4.3 Building B elevations

Building B south elevation current proposed changes

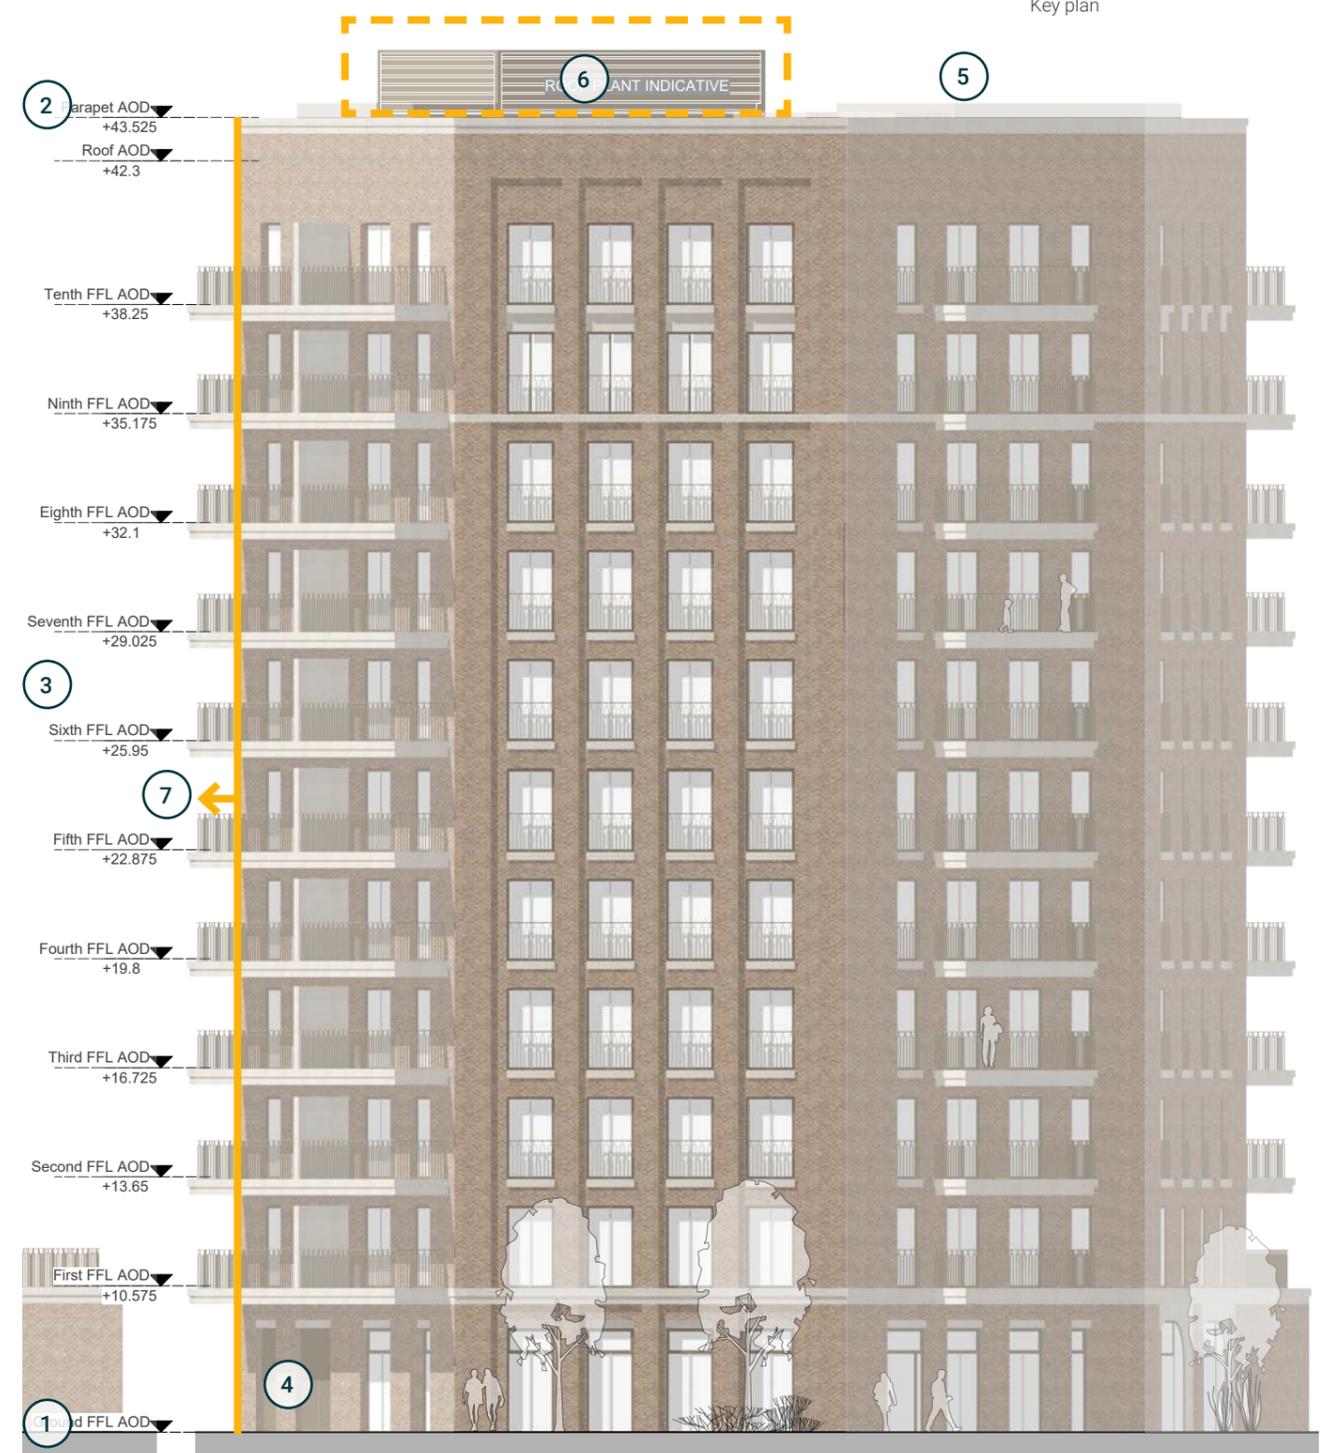
- 1 Ground floor FFL increased by 15cm from +6.3 to +6.45
- 2 Parapet height reduced by 15cm (from +43.675 to +43.525)
- 3 Floor to floor heights (1st to 10th floors) each reduced by 7.5cm
- 4 New louvred double doors required for access to substation
- 5 Residential terrace removed
- 6 Roof plant enclosure consolidated
- 7 a 112.5mm (or 11.25cm) extension in building footprint to the south

Building B south-west elevation current proposed changes

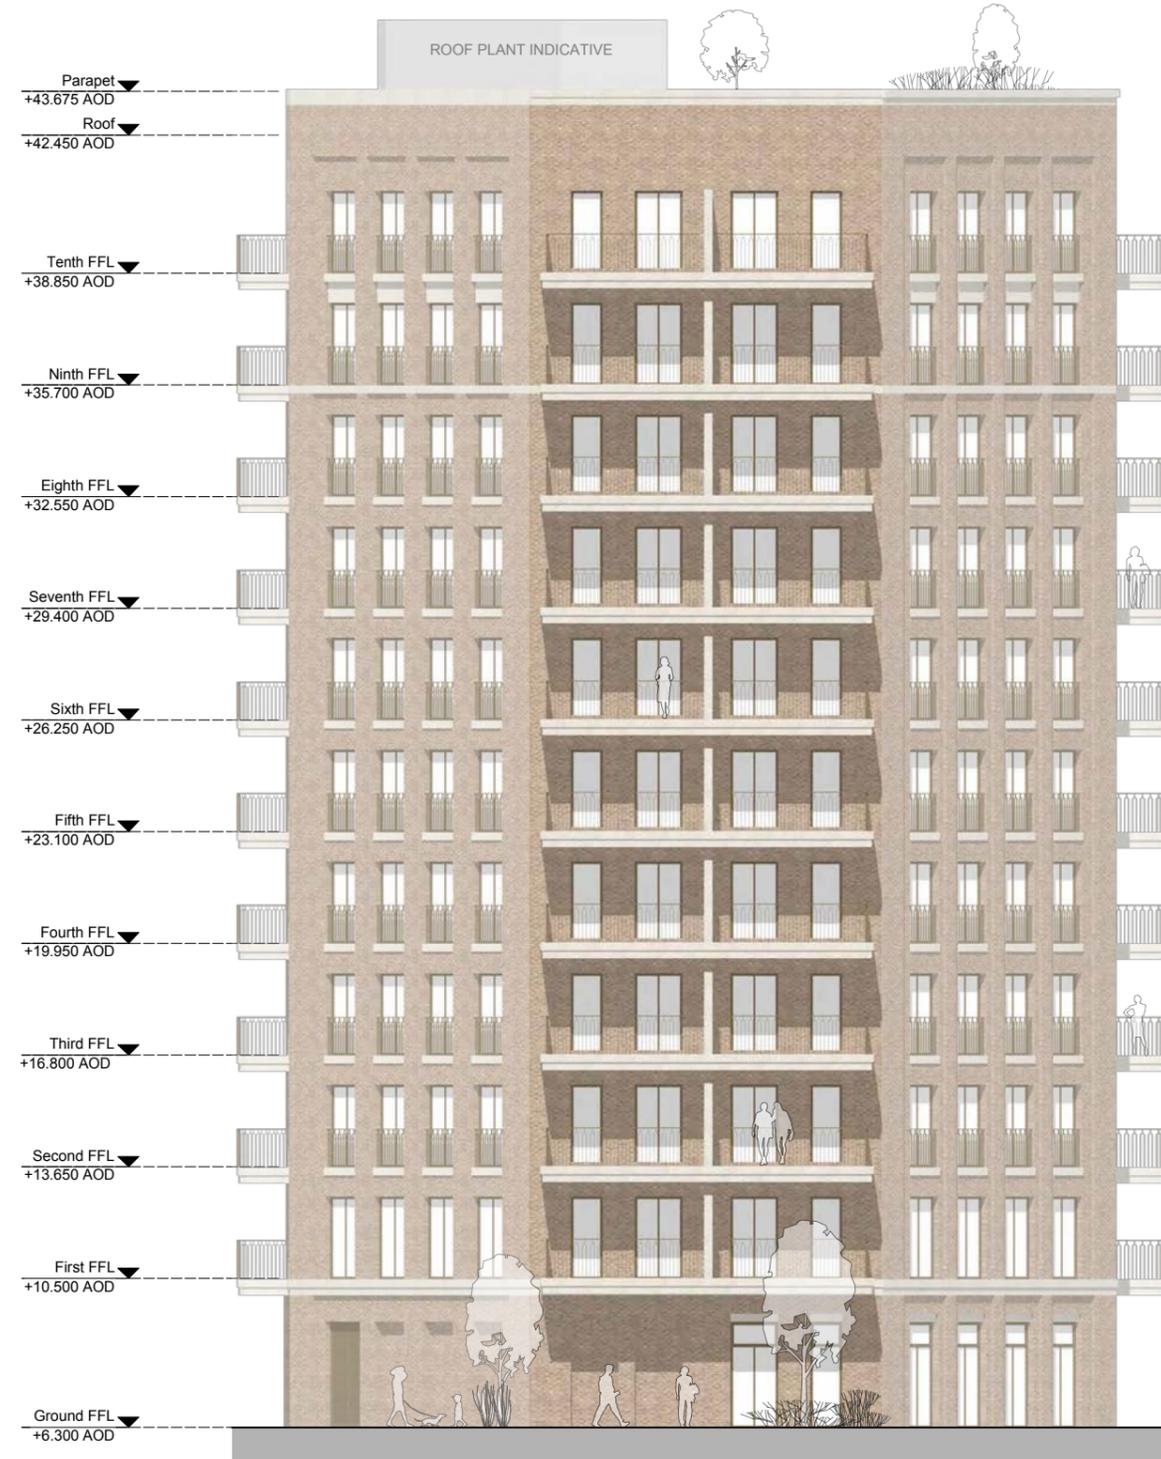
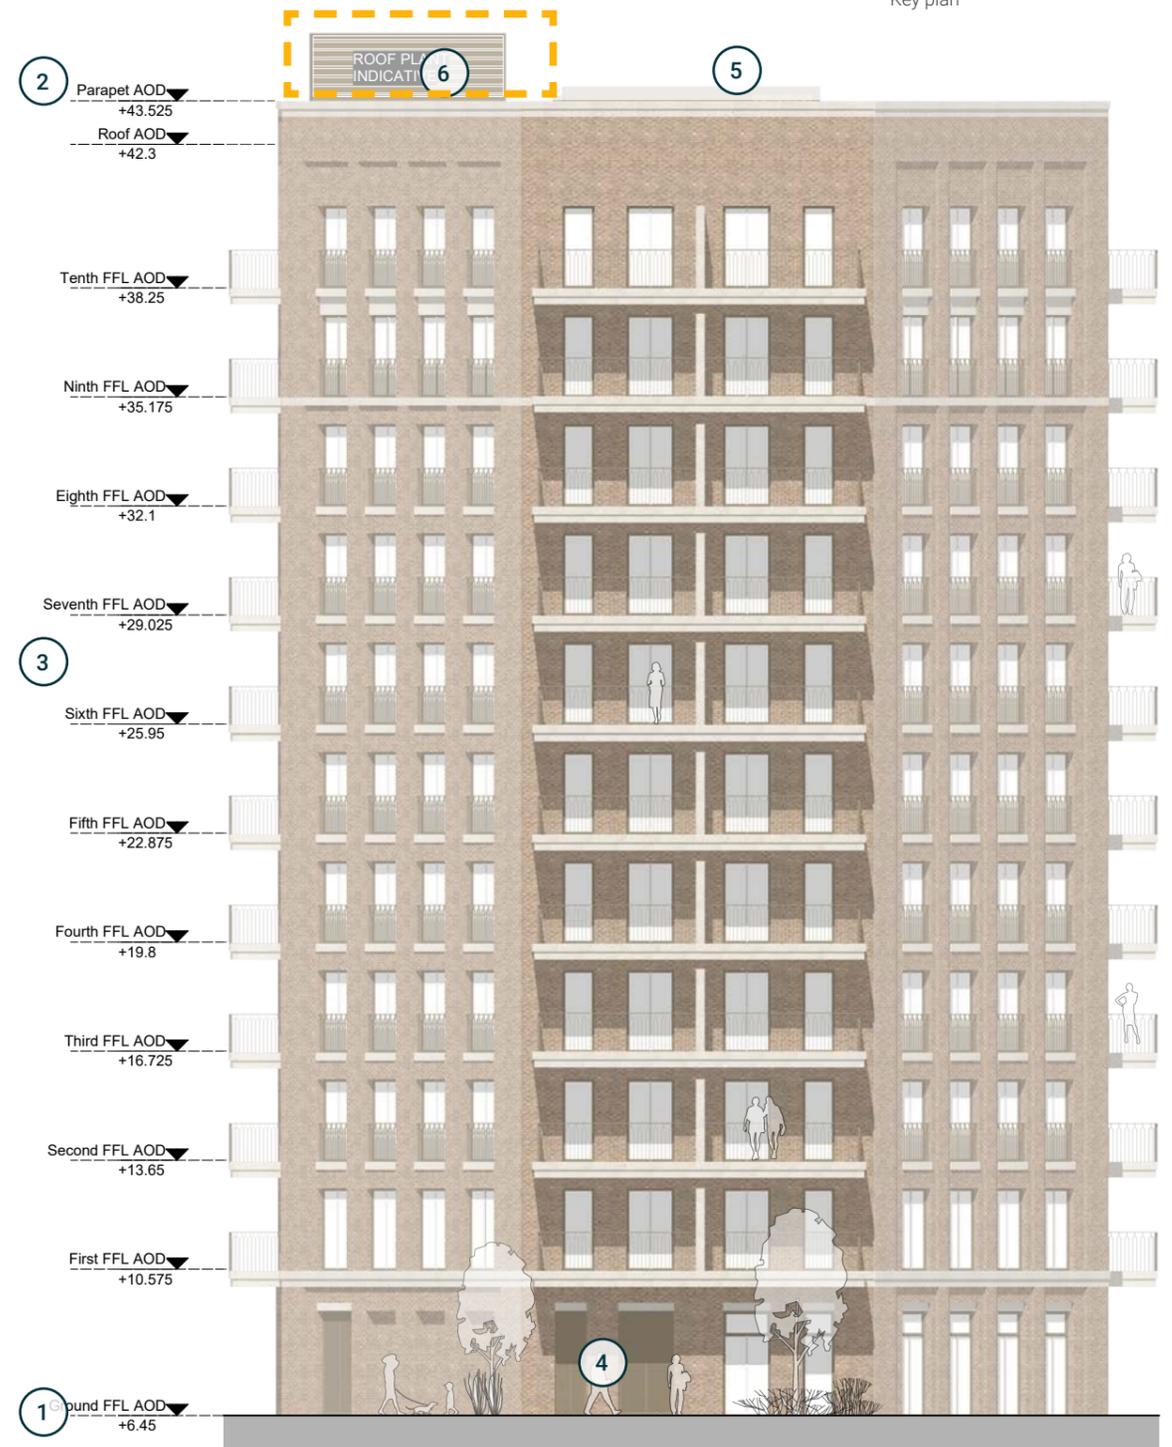
- 1 Ground floor FFL increased by 15cm from +6.3 to +6.45
- 2 Parapet height reduced by 15cm (from +43.675 to +43.525)
- 3 Floor to floor heights (1st to 10th floors) each reduced by 7.5cm
- 4 New louvred double doors required for access to substation
- 5 Residential terrace removed
- 6 Roof plant enclosure consolidated

Building B west elevation current proposed changes

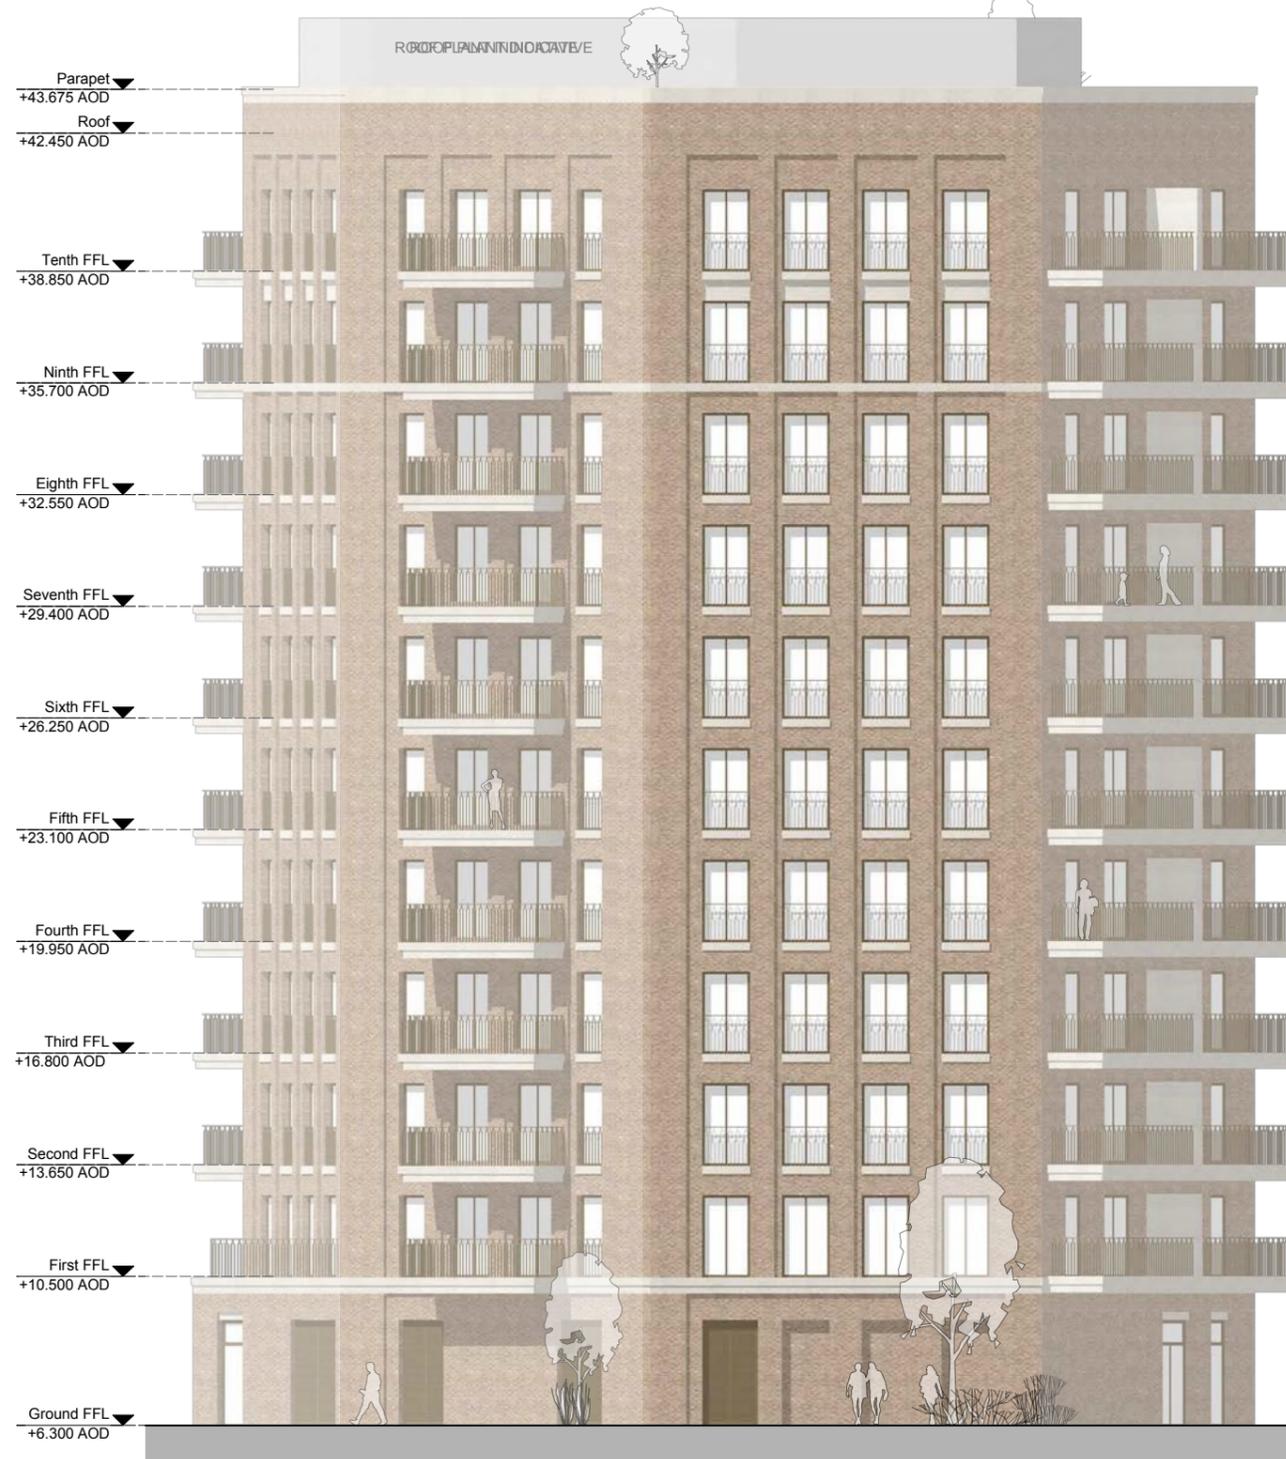
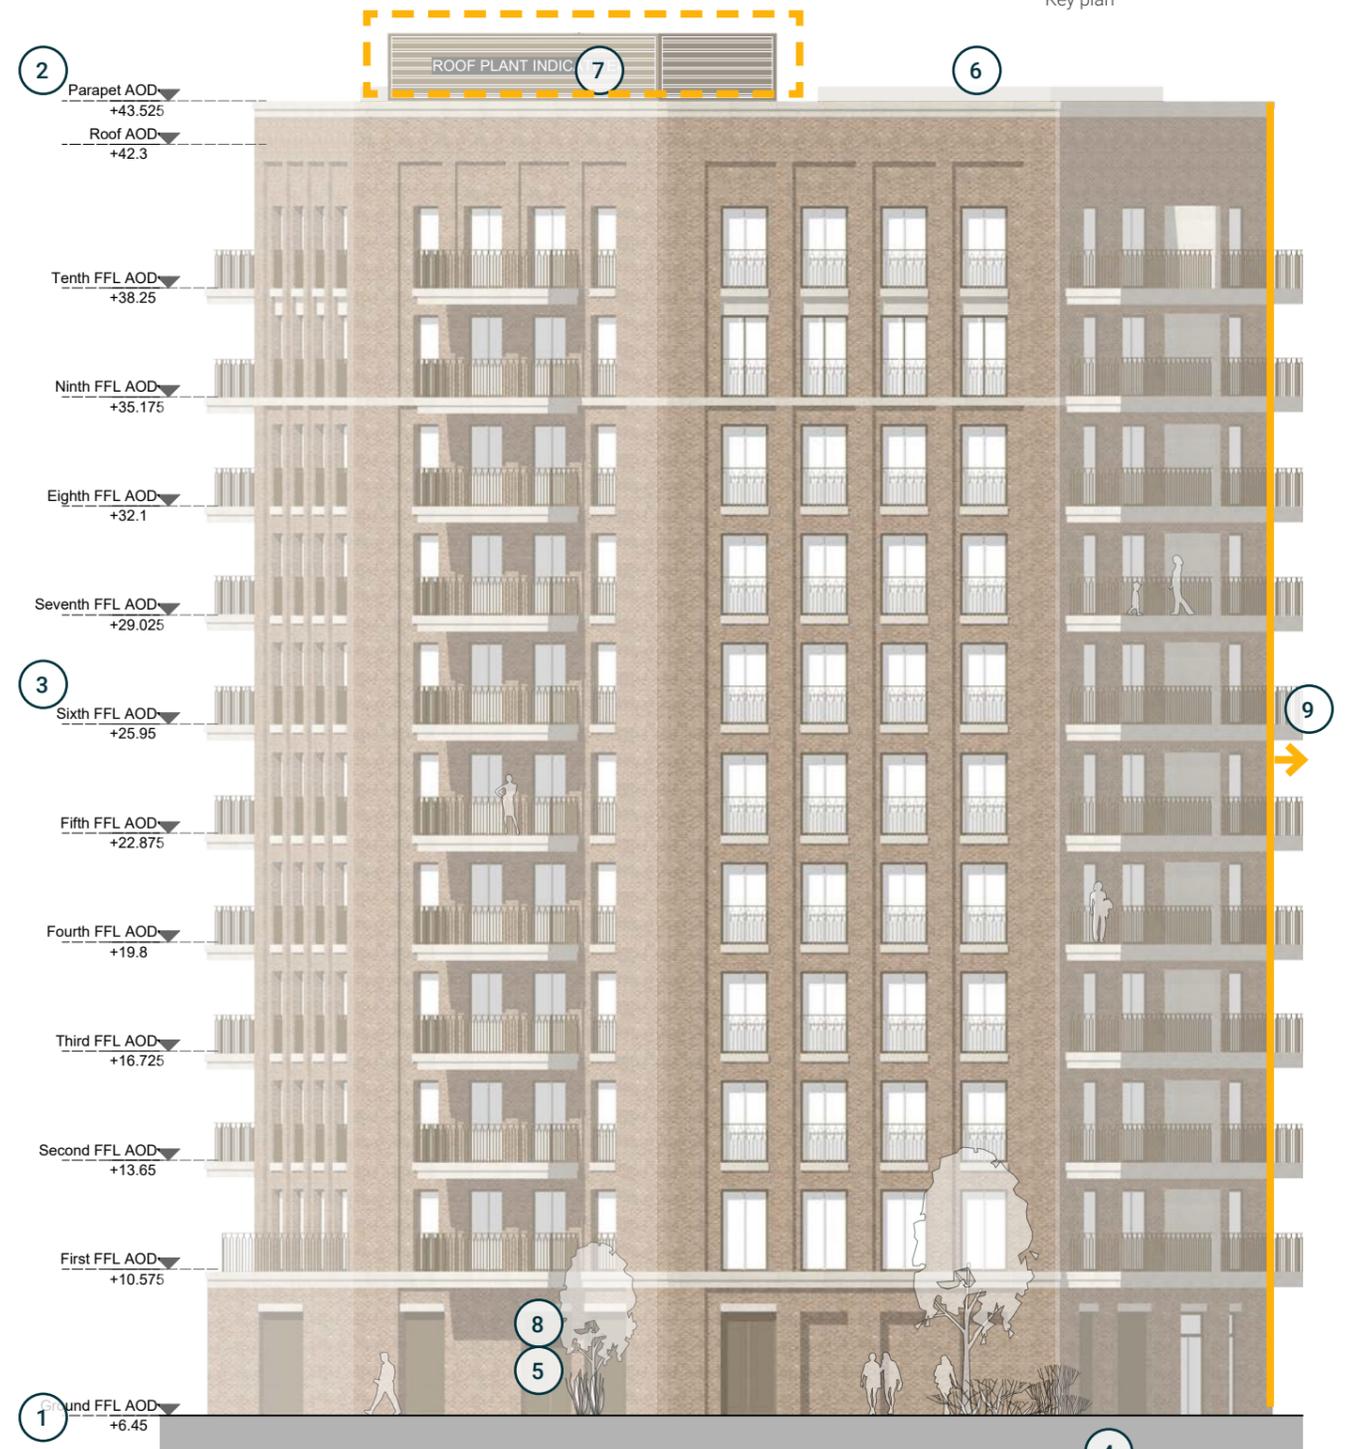
- 1 Ground floor FFL increased by 15cm from +6.3 to +6.45
- 2 Parapet height reduced by 15cm (from +43.675 to +43.525)
- 3 Floor to floor heights (1st to 10th floors) each reduced by 7.5cm
- 4 New louvred double doors required for access to substation
- 5 New escape door for means of escape from stair core and adjustments to doors for bin stores, bike stores and plant rooms accordingly.
- 6 Residential terrace removed
- 7 Roof plant enclosure consolidated
- 8 Arrangement of external doors amended to current proposed ground floor layout.
- 9 a 112.5mm (or 11.25cm) extension in building footprint to the south
